**RESOLUTION SETTING HEARING ON REQUEST FROM ABC PARTNERS, LP FOR APPROVAL OF A PROPOSED 2<sup>ND</sup> AMENDMENT TO THE AIRPORT BUSINESS PARK PHASE II PUD CONCEPTUAL PLAN ON PROPERTY LOCATED AT 7404 SW 37<sup>TH</sup> STREET**

(ZON2021-000058)

Communication from the City Plan and Zoning Commission advising that at their January 20, 2022 meeting, the following action was taken regarding a request from ABC Partners, LP (owner), represented by Ronald L. Daniels (officer), for review and approval of a 2<sup>nd</sup> amendment to the Airport Business Park Phase II PUD Conceptual Plan on the property located at 7404 SW 37<sup>th</sup> Street, to update descriptions for permitted uses on Lots 1 and 2 of the PUD and to replace the requirement of a 10-foot-wide bicycle path with a 5-foot wide sidewalk.

**AIRPORT BUSINESS PARK PHASE 2 PLANNED UNIT DEVELOPMENT**

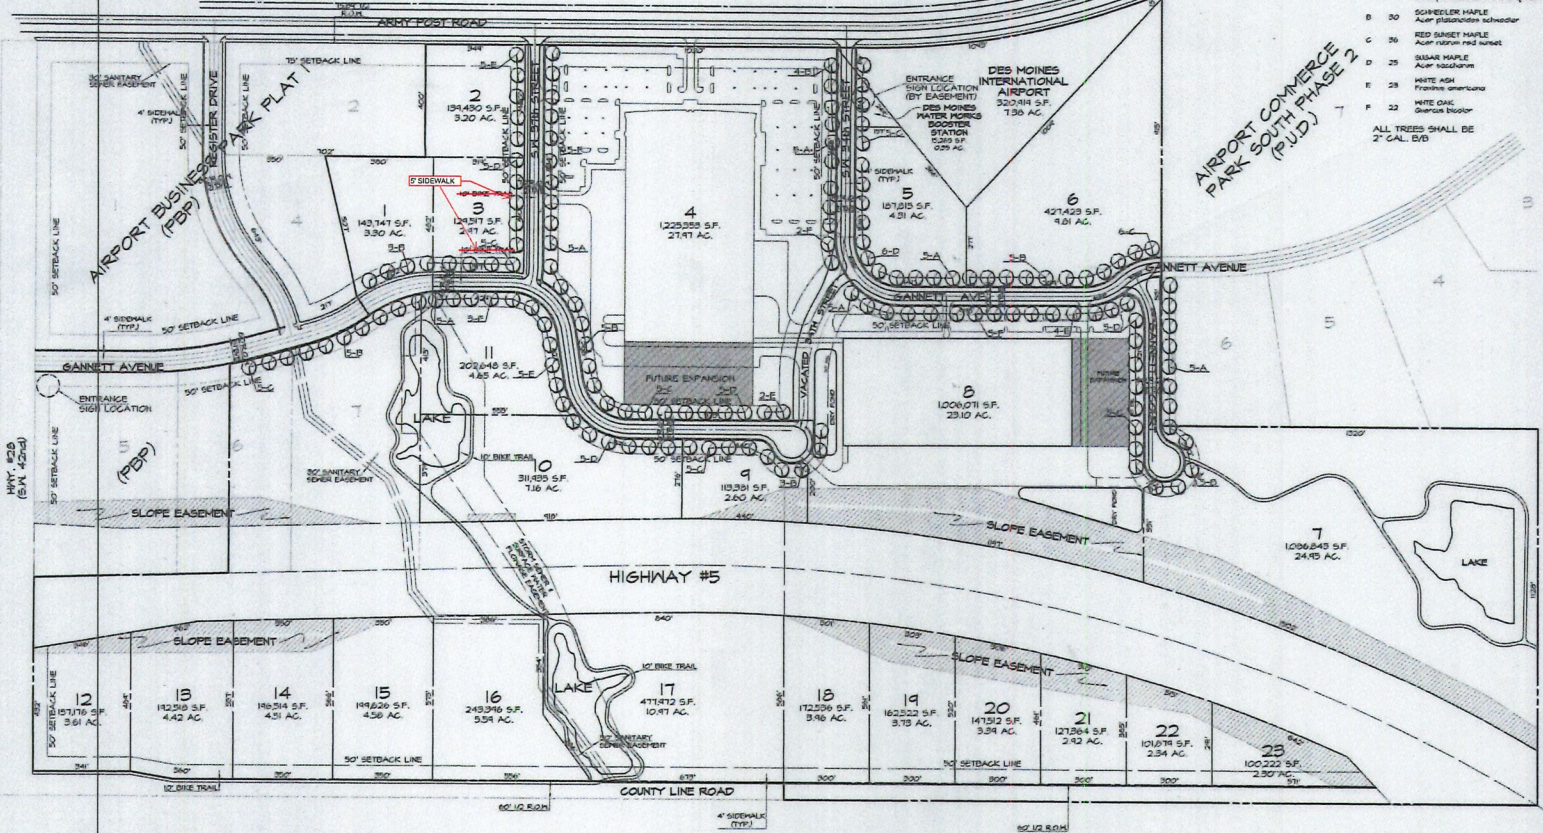
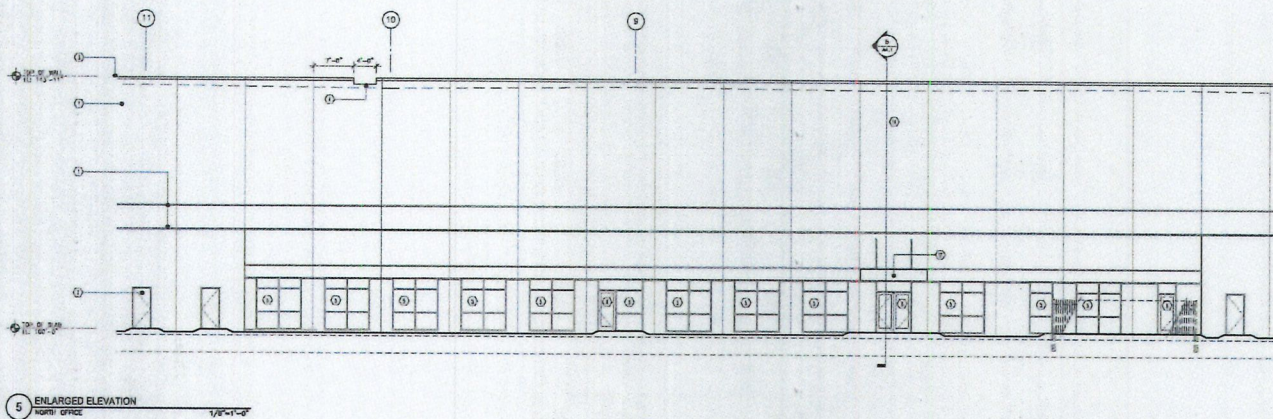
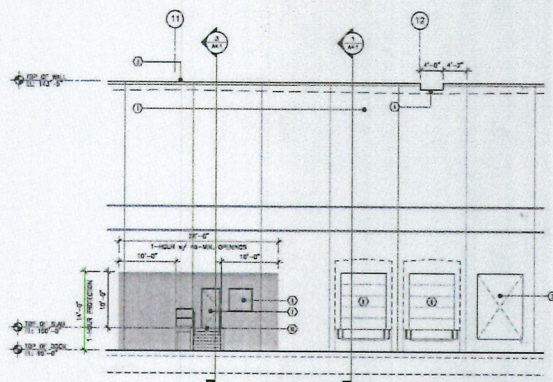
5. **Off-Street Parking:** The City’s standard off-street parking requirement for a manufacturing use is 1 parking stall per 2 employees plus 1 parking stall per 400 square feet of office space. The submitted Conceptual Plan indicates that parking should be in accordance with parking requirements of Des Moines Ordinance Section 134-1377.

8. **Lighting:** The proposed “PUD” Conceptual Plan does not comment on the provision of lighting. Lighting should enhance safety and provide light levels appropriate to the visual task with minimal glare, light trespass and excess site brightness.

9. **Trash Enclosure:** The “PUD” Conceptual Plan indicates that the trash enclosure shall be integrated into the overall architectural design of the building by being fully enclosed or screened with compatible fencing and plant material.

10. **Signage:** The “PUD” Conceptual Plan proposes that signage shall be in accordance with C-1 Zoning Classification.

Staff recommends that the parking note be updated to reflect the new code to state

that “parking shall be provided in accordance with Chapter 135: Planning and Design Code”.

Staff recommends provision of a note stating that all lighting shall be provided in accordance with Chapter 135: Planning and Design Code.

Staff recommends provision of a note stating that any refuse collection container shall be within an enclosure constructed of masonry walls that match the primary building and steel gate with a pedestrian entrance or shall be fully enclosed within the building.

Staff recommends provision that the signage note be updated to state that all signage shall be provided in accordance with MX1 Zoning Classification per Chapter 134: Zoning Code.
